**Addendum No. 2  
To the Plans, Specifications, Proposal and Contract**

**City of Kirkland  
Fire Station 24  
9824 NE 132<sup>nd</sup> ST, Kirkland WA 98034  
CIP # PSC 3002 200  
JOB # 32-20-PW**

ISSUED THIS DATE: August 10, 2020

**PARTIAL ROOF PLAN AT ENTRY CANOPY**

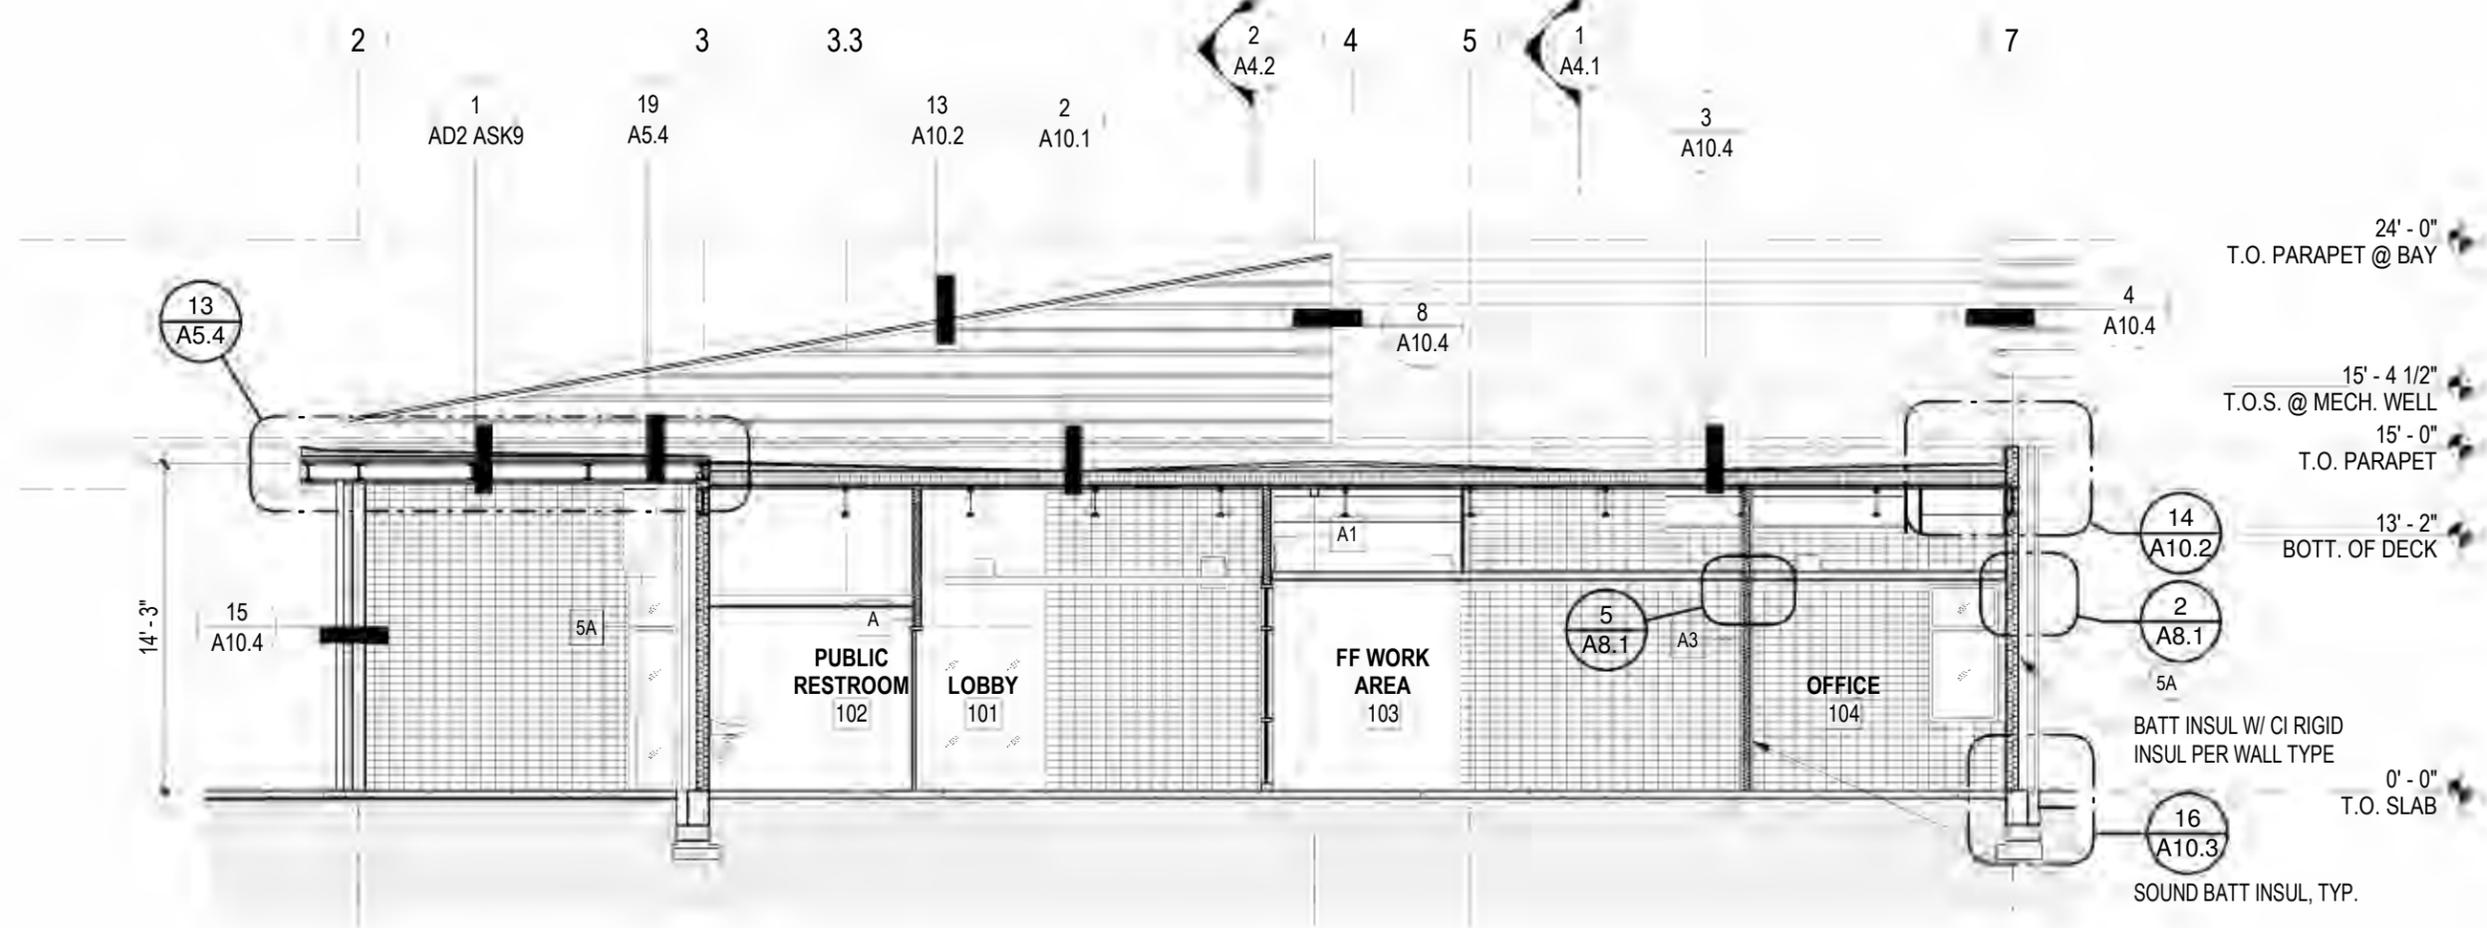
- a. Refer to attached sketch AD2 ASK1 Partial Roof Plan at Entry Canopy for revisions to roof plan.

**REVISED EAST-WEST SECTION THRU LOBBY**

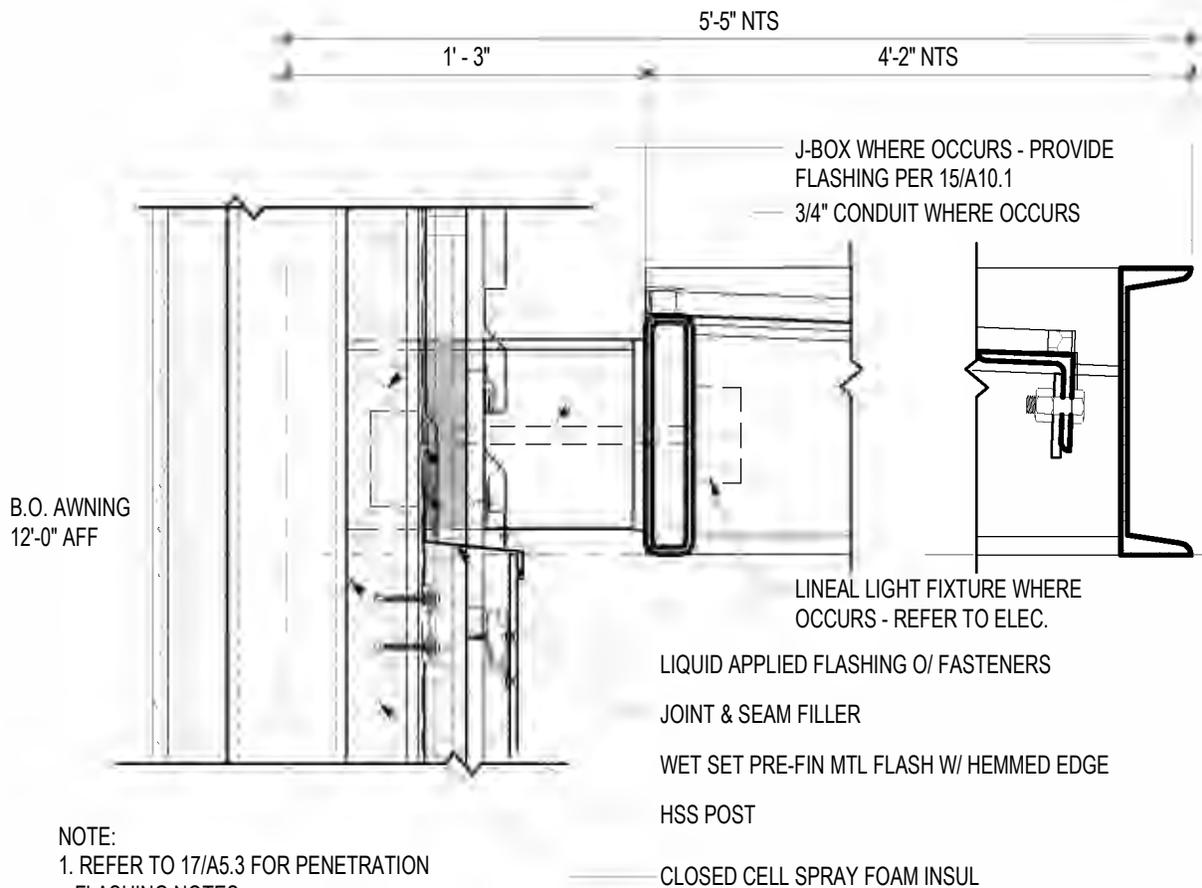
- a. Refer to attached sketch AD ASK2 Revised East-West Section Thru Lobby for revision to building section 6/A4.2.

**REVISED AWNING @ HPL/ MTL TRANSITION**

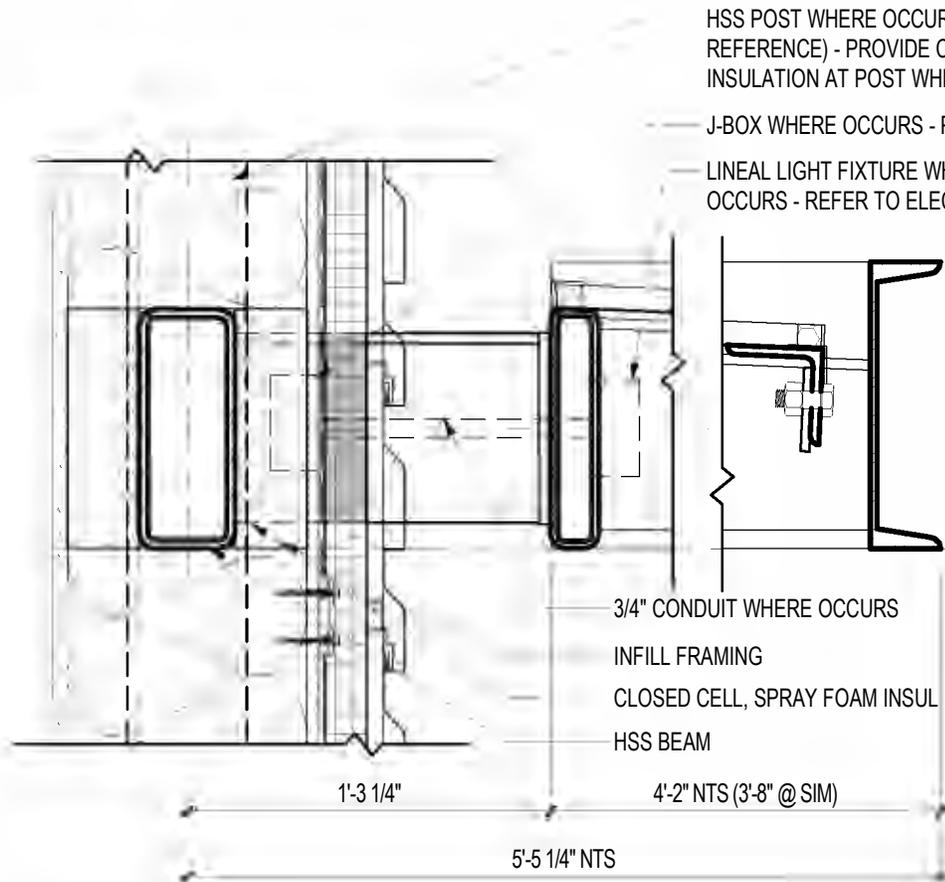
- a. Replace detail 8 with attached sketch AD2 ASK3 Revised Awning @ HPL/Metal Transition.
- b. Replace detail 11 with attached sketch AD2 ASK4 Revised Awning at Metal Siding.

**REVISED ENTRY CANOPY E/W SECTION**

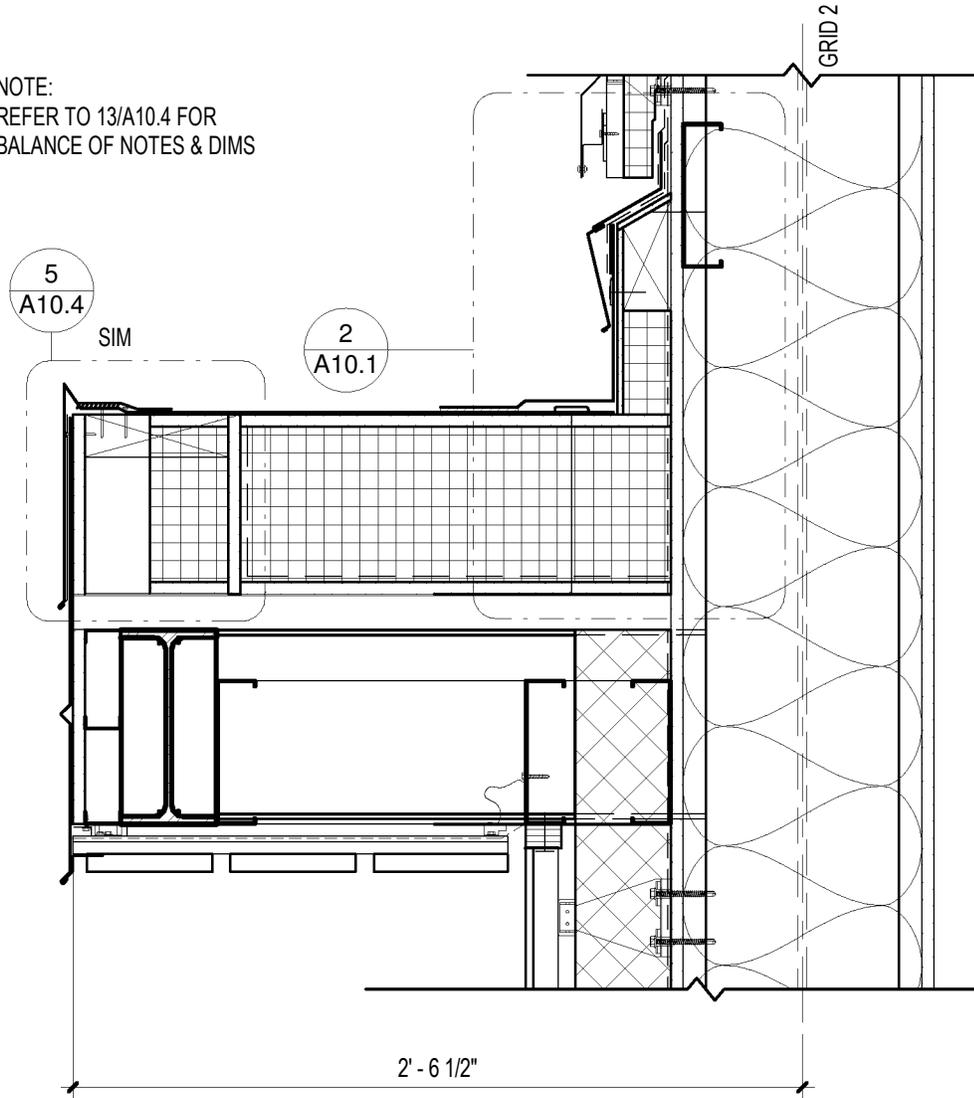
- a. Replace detail 13 with attached sketch AD2 ASK5 Revised Entry Canopy E/W Section
- b. Replace detail 17 with attached sketch AD2 ASK6 Revised Entry Canopy at HPL
- c. Replace detail 18 with attached sketch AD2 ASK7 Revised Entry Canopy at Brick Veneer
- d. Replace detail 19 with attached sketch AD2 ASK8 Revised Entry Canopy N/S Section
- e. Add detail 20 via attached sketch AD2 ASK9 Entry Canopy at Grid L

AD2  
SSK-2  
REVISED BF-5 ELEV.  
S6.1

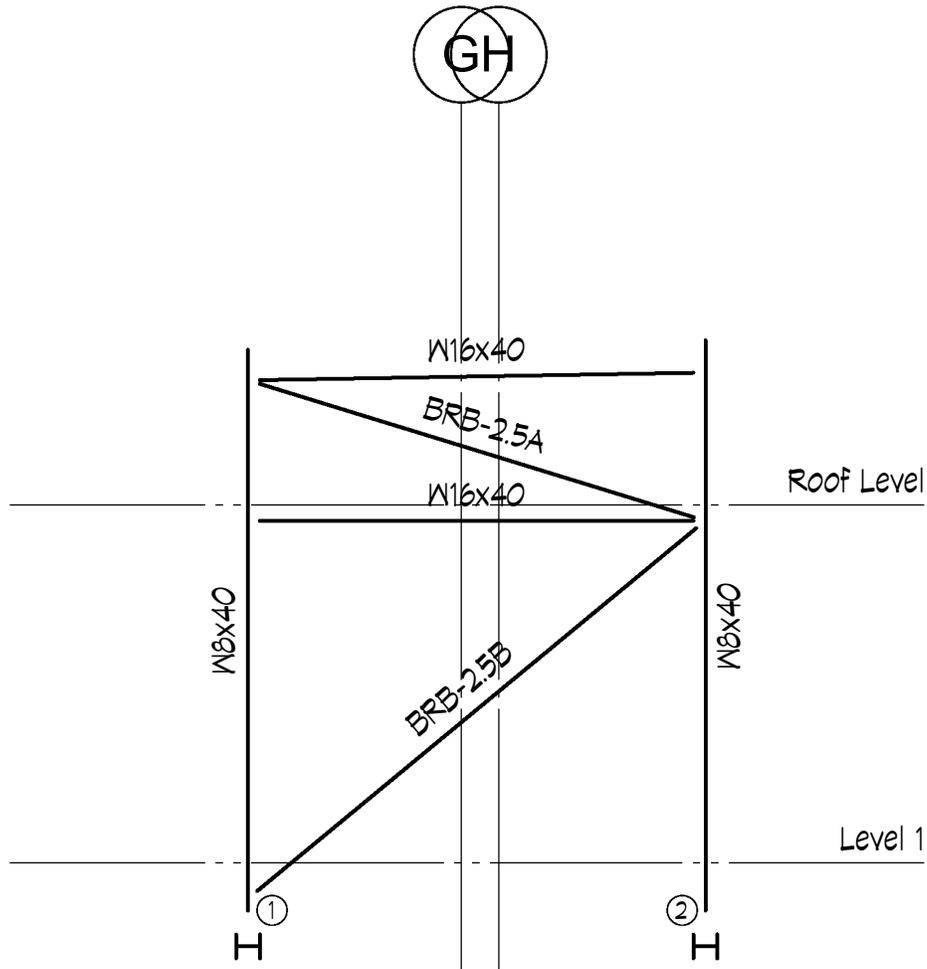
- a. BF-5 is revised per AD2 SSK-2 -attached.

AD2  
SSK-4  
REVISED 13/S5.6

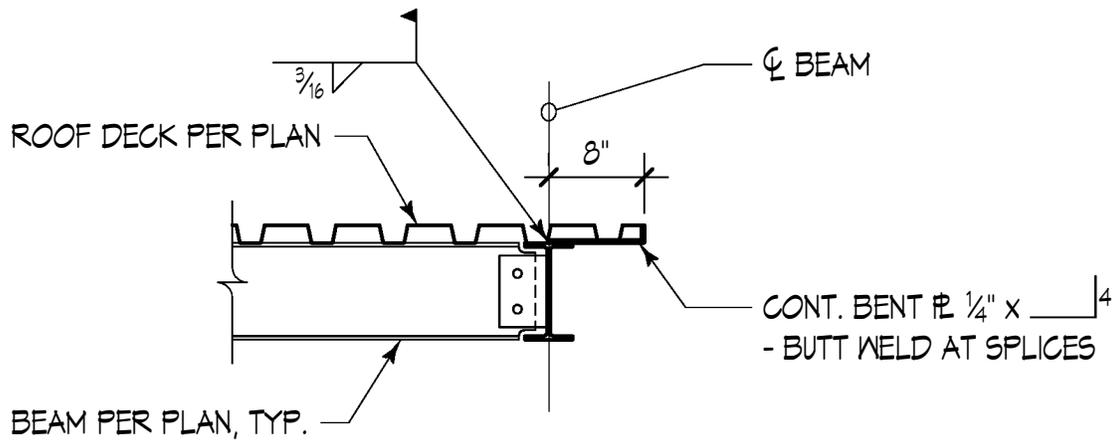
- a. Detail 6/S5.6 is added by AD2 SSK-1 -attached.
- b. Detail 13/S5.6 is revised to show 8" deck edge dimension with a cont. bent plate per AD2 SSK-4 -attached.
- c. Details 10/S5.6 and 2/S5.6 revise note per Structural Drawings Item 3a -above.

Project number	18040	<b>AD2</b> <b>MSK-3</b> Scale NTS
Date	8/10/20	
Reference Sheet	<b>M1.4</b>

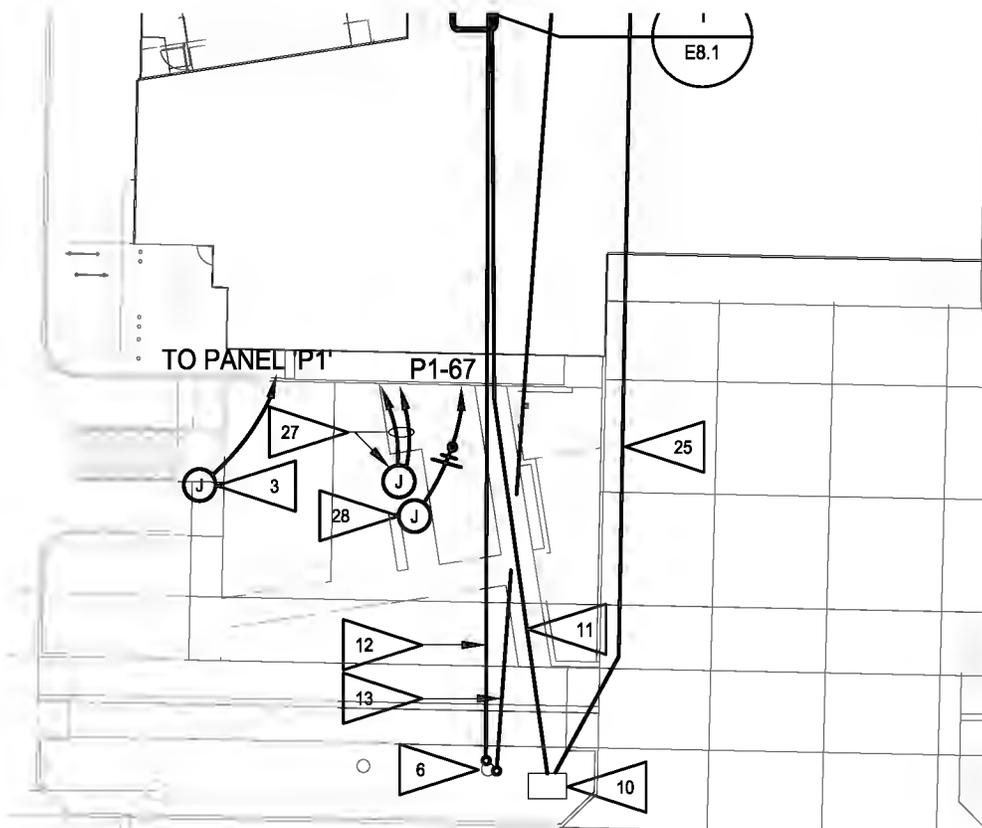
- a. See revised sequence on AD2 MSK-3 -attached.

REFERENCE SHEET:  
**E1.1**

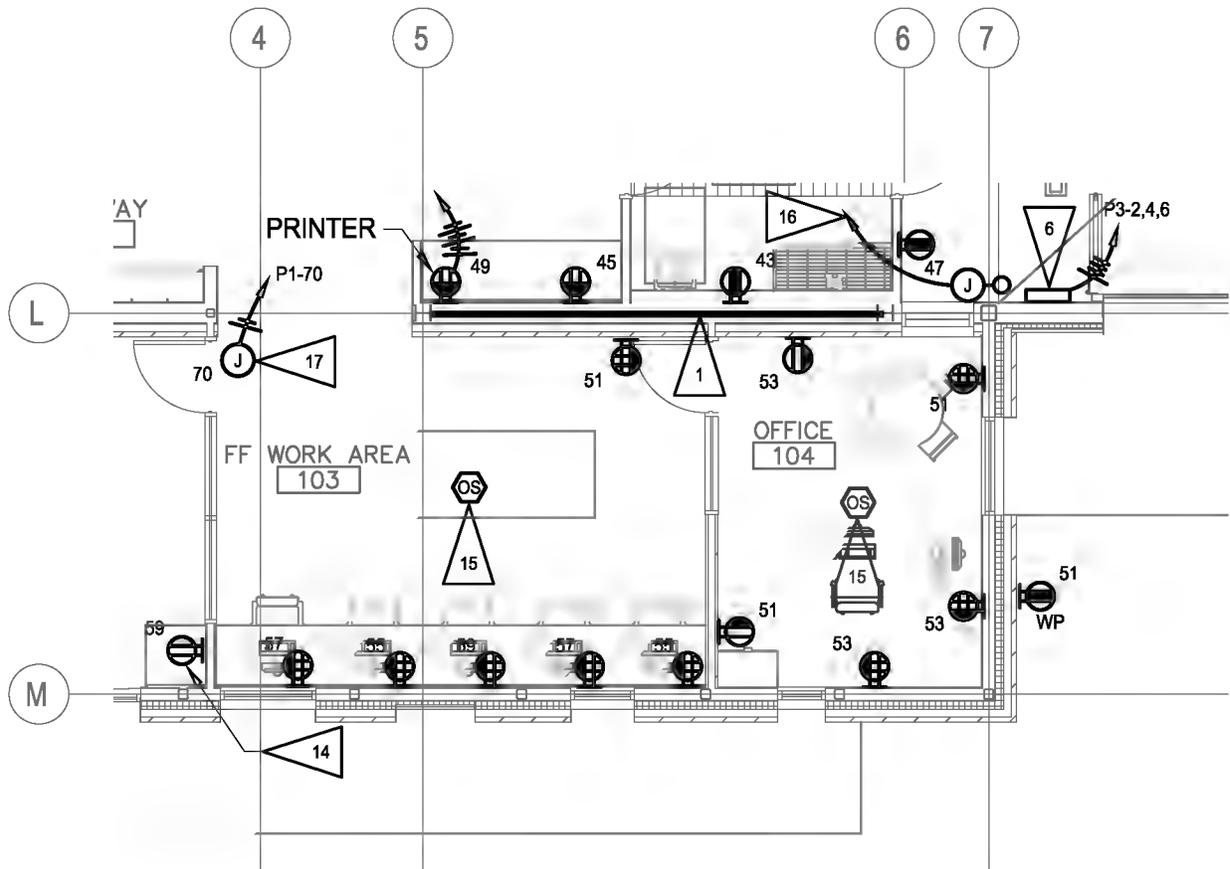
- a. Revise Flag Note 27 per attached sketch AD2 ESK-2.
- b. Add homerun at site artwork per attached sketch AD2 ESK-2.
